TFT Display Differences

The RM420-015B replaces the RM420-015. All orders will be changed automatically. The only difference is the power supply.

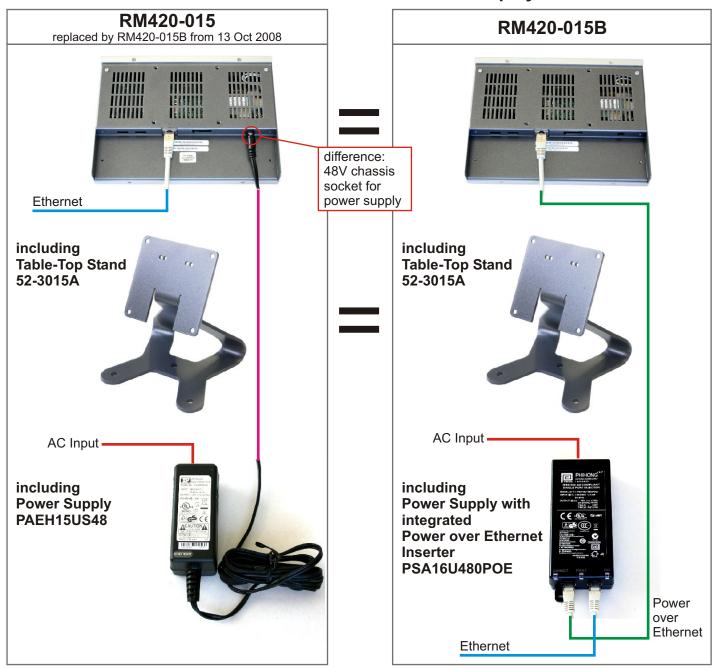
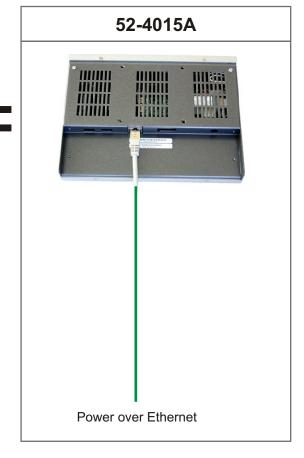
The RM420-015B is supplied by Power over Ethernet using a power supply with integrated Power over Ethernet inserter (PSA16U480POE). What is different in the display hardware is the now eliminated 48V socket for the 48V power supply.

If you order a 52-4015A, a 52-3015A and a PSA16U480POE together, you will receive the same hardware kit as in item RM420-015B.
